# Access Compliance Report

## Public Rights-of-Way

### (Curb Ramps)

Intersection ID: 21560	Main Street: RITTENHOUSE_CR	Cross Street: SARDIS_RD_NORTH	Location: SE
ADA ID: 9286086D20A2	Ramp Type: PerpDiag	Initial Pass/Fail: Fail	Overall Compliance: No
			Severity Score: 26.25

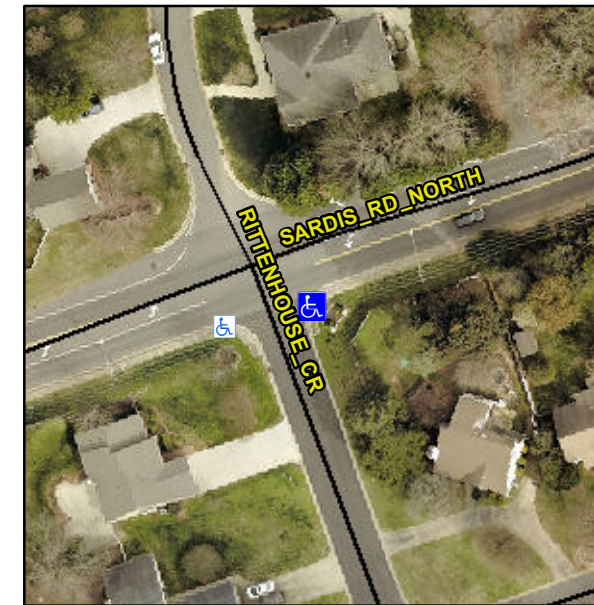
**R304.2.2, R304.5.3**

Compliance	Description	Data	Compliance	Description	Data
N/A	Ramp Length (in)	48.0	No	Ramp Slope (%)	14.4
Yes	Ramp Width (in)	48.0	No	Ramp XSlope (%)	4.4
N/A	Flare Type LT	N/A	N/A	Flare Type RT	N/A
N/A	Flare Slope LT (%)	N/A	N/A	Flare Slope RT (%)	N/A
N/A	Flare Traversable LT?	N/A	N/A	Flare Traversable RT?	N/A
N/A	Landing Length (in)	N/A	N/A	DWS Provided?	N/A
N/A	Landing Width (in)	N/A	N/A	DWS Contrast?	N/A
N/A	Landing Slope (%)	N/A	N/A	DWS Length (in)	N/A
N/A	Landing X Slope (%)	N/A	N/A	DWS Full Width?	N/A
N/A	Landing Curb? (Y/N)	N/A	N/A	DWS Offset (in)	N/A
N/A	Shared Landing?	N/A			
N/A	Gutter Ponding?	N/A	N/A	Gutter Slope (%)	N/A
N/A	Gutter Lip Ht (in)	N/A	N/A	Gutter X Slope (%)	N/A
N/A	Painted X Walk1?	No	N/A	Painted X Walk2?	No
	X Walk 1 Direction	To N		X Walk 2 Direction	To W
N/A	X Walk 1 Width (in)	N/A	N/A	X Walk 2 Width (in)	N/A
	X Walk 1 Slope (%)	4.2		X Walk 2 Slope (%)	0.7
	X Walk 1 X Slope (%)	2.8		X Walk 2 X Slope (%)	2.2

**Remove & Replace Curb Ramp With Two New Directional Ramps or Equivalent.**
